SUNDRY NOTICES AND REPORTS ON WELLS

Sterling Silver 33 Federal #9
API No: 30-015-33975

Sterling Silver 33 Federal 9
30-015-33975
OXY USA Inc.
September 1, 2011
Conditions of Approval

OXY USA Inc. - Proposed
Sterling Silver 33 Federal Deep #9
API No. 30-015-33975

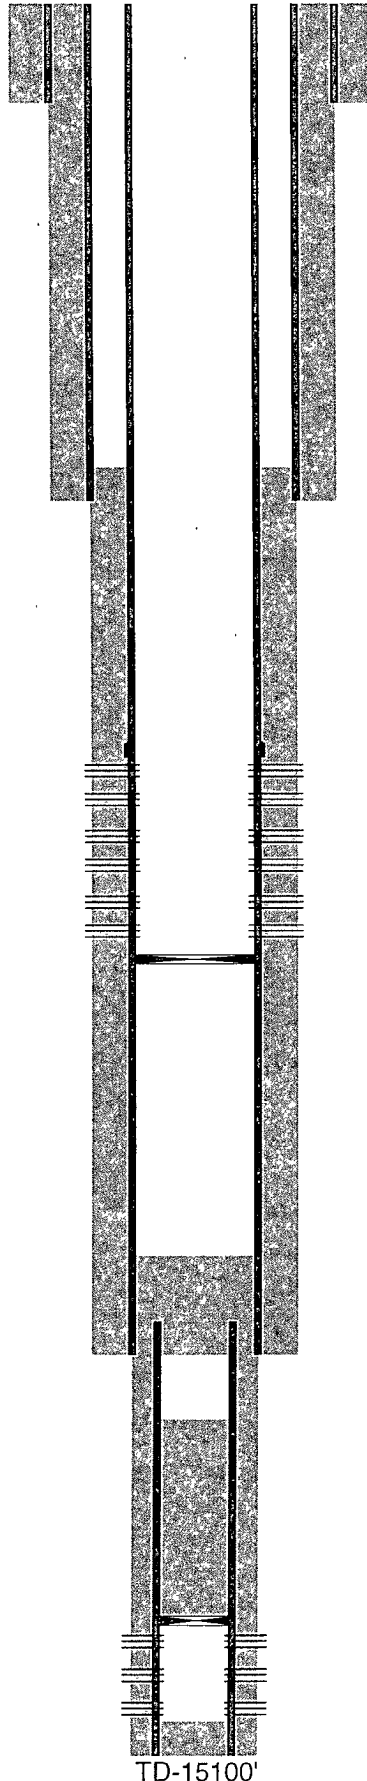
1. **Contact BLM 575-361-2822 a minimum of 24 hours prior to performing operations.**
2. **Plug from 14,360-12,360 will require more than 25 sxs, otherwise, ok. WOC and Tag**

3. **The Liner stub plug must extend 50 feet below the 7" casing shoe from 11,770-11,325'. WOC and tag.**
4. **Move the CIBP to 8325' and dump bail 35' of cement on top to satisfy maximum spacing from previous plug. Cement can be used to get TD to 8100 feet, but a plug will be required across the top of the Bone Springs (8033') at final plugging.**
